**City of Portland, Maine – Building or Use Permit Application** 389 Congress Street, 04101, Tel: (207) 874-8703, FAX: 874-8716

Proposed Project Description:(Please be as specific as possible)  
Replace 9'x14' room addition

# BUILDING PERMIT REPORT

DATE: 14 OCT. 98 ADDRESS: 1 Russell Street CBL 054-C-004  
REASON FOR PERMIT: - Replace - 9'x14' addition  
BUILDING OWNER: DAVE Hamlin  
CONTRACTOR: Gregg Car michael  
PERMIT APPLICANT: \_\_\_\_\_  
USE GROUP R-3 BOCA 1996 CONSTRUCTION TYPE 5B

RE:replacement of sun porch

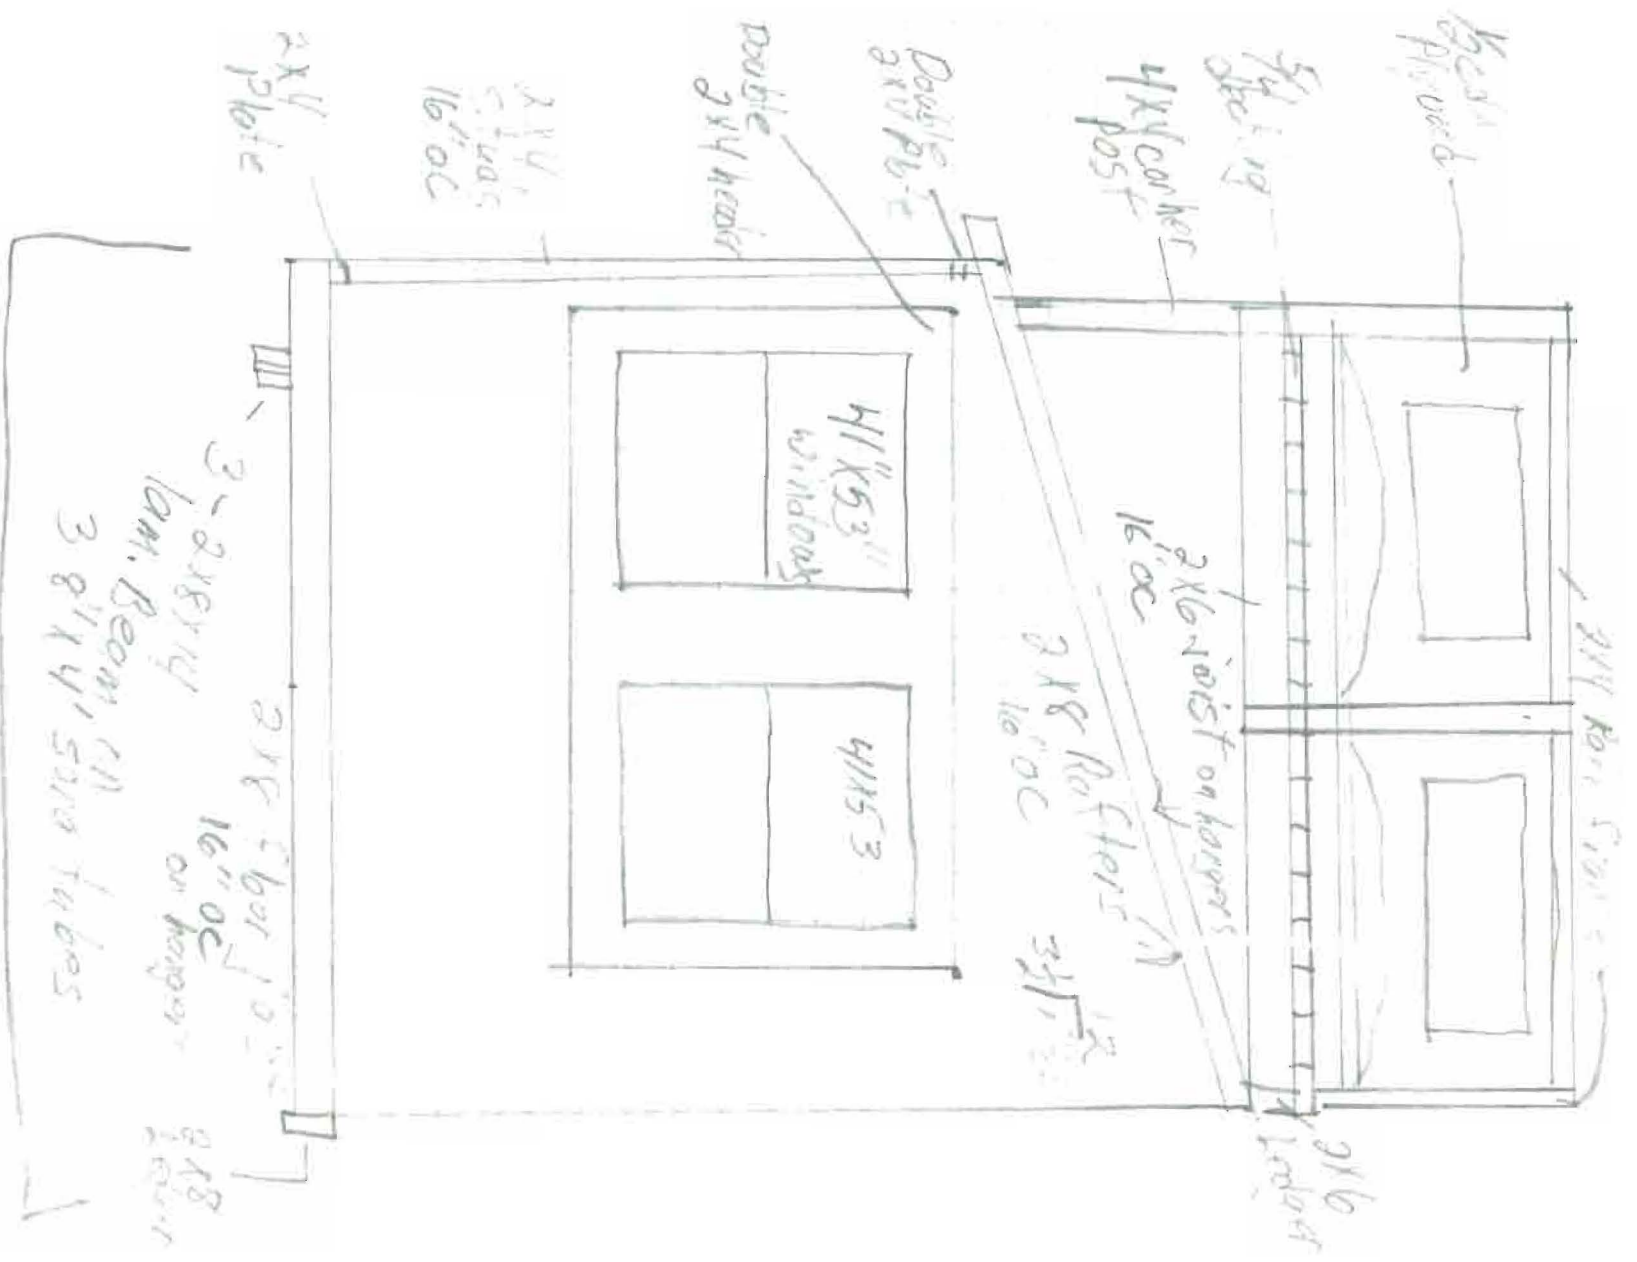
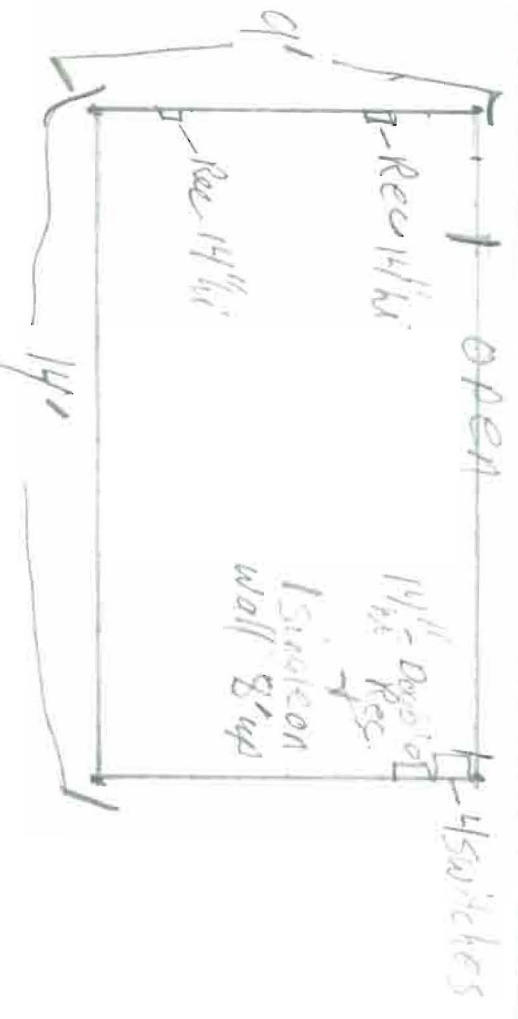
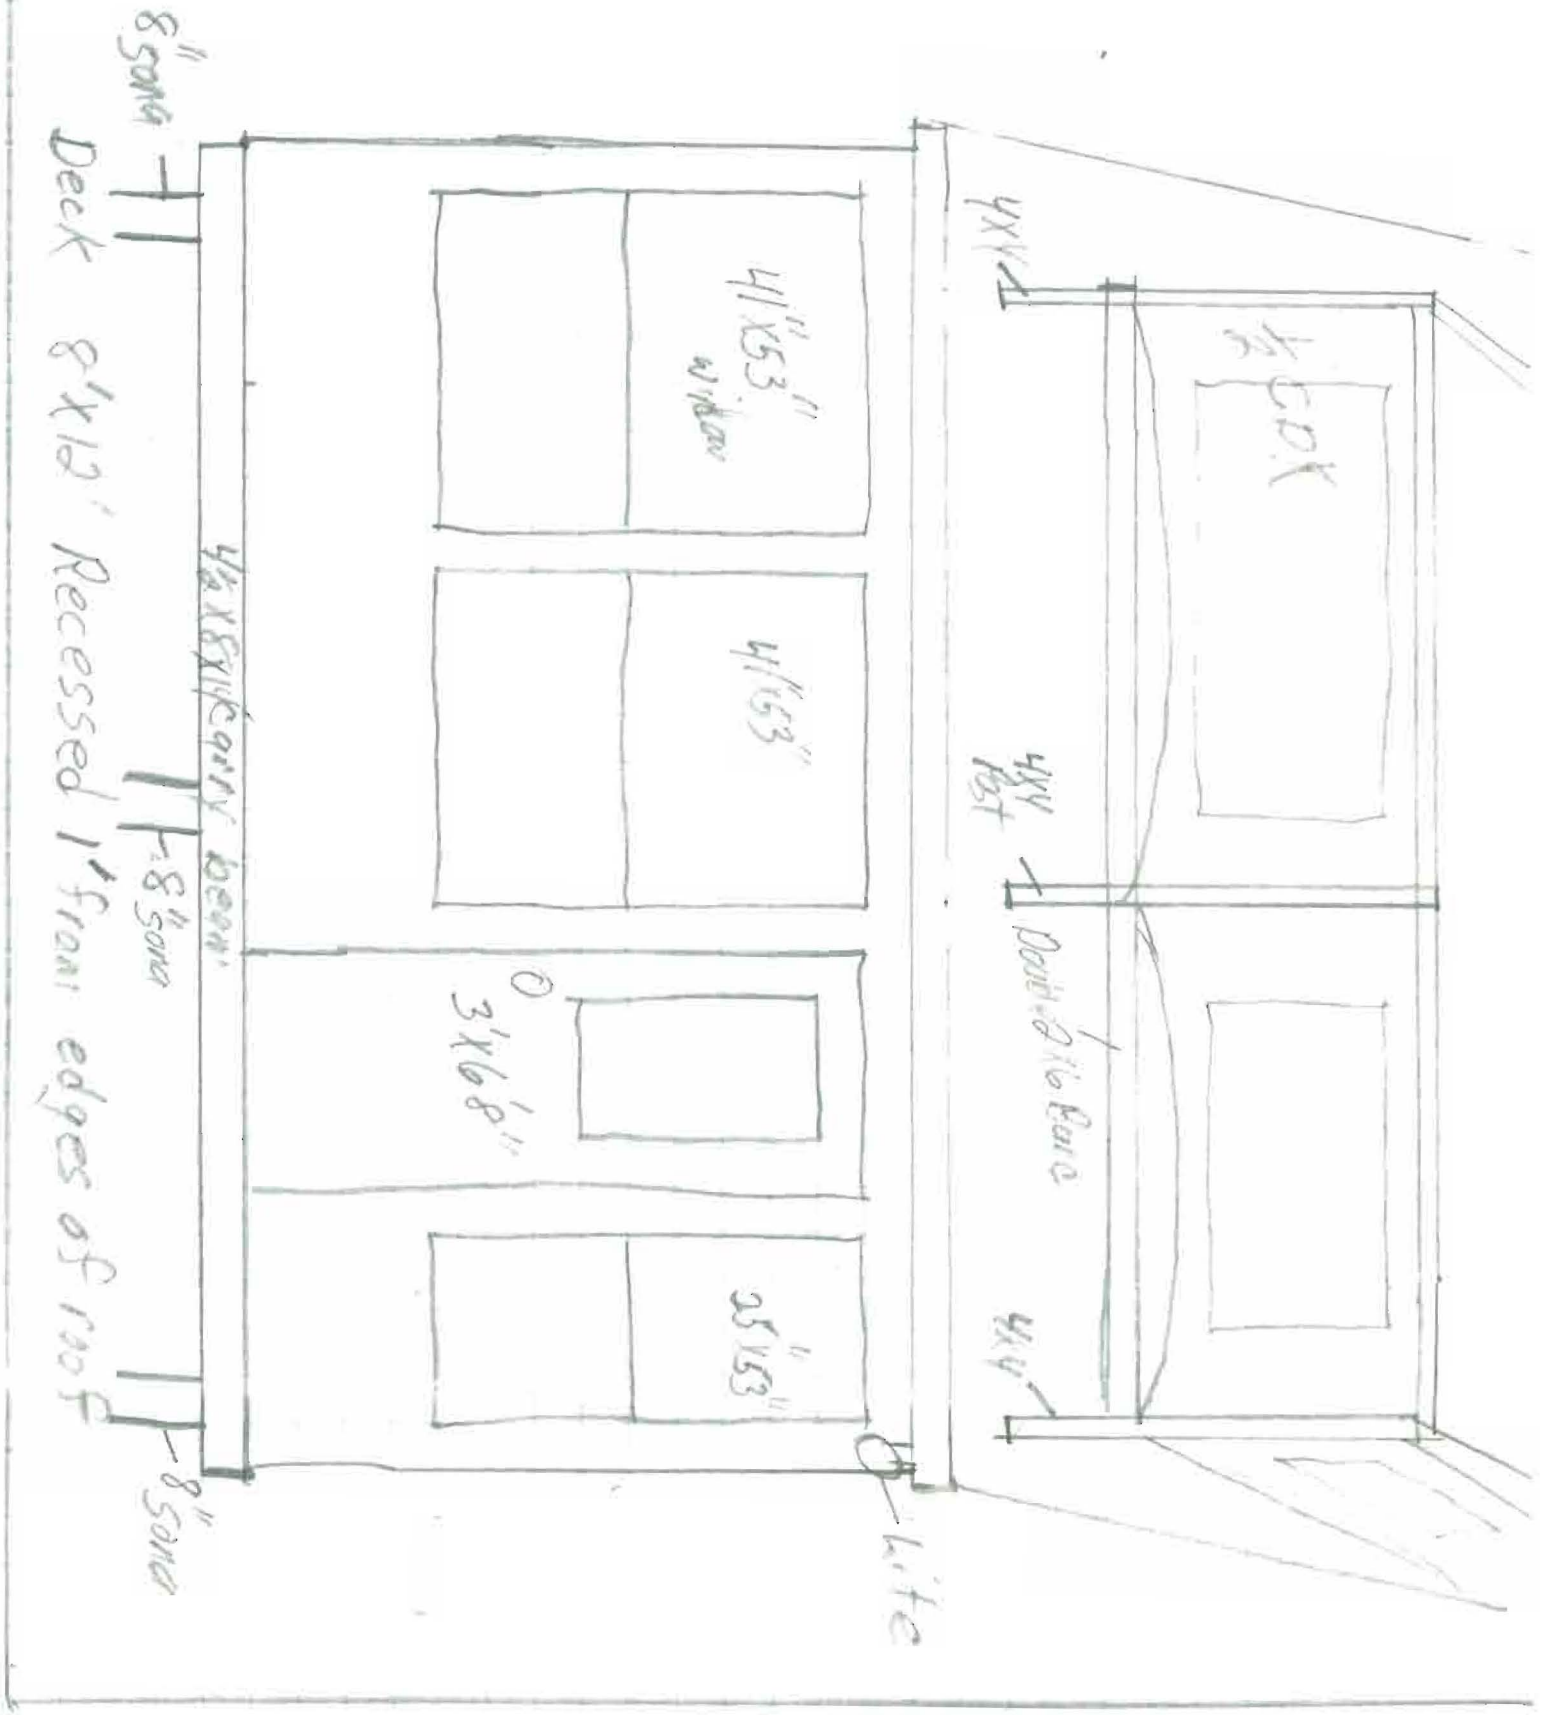
- Q 30. Glass and glazing shall meet the requirements of Chapter 24 of the building code.
- X 31. Your proposed foundation 8" (piers) sonotubes must be on footing with anchor connecting the two - ALSO The top of sonotube must have fastening dev. between tube and framing.

32. The proposed roof deck must have full bearing to framing members below -
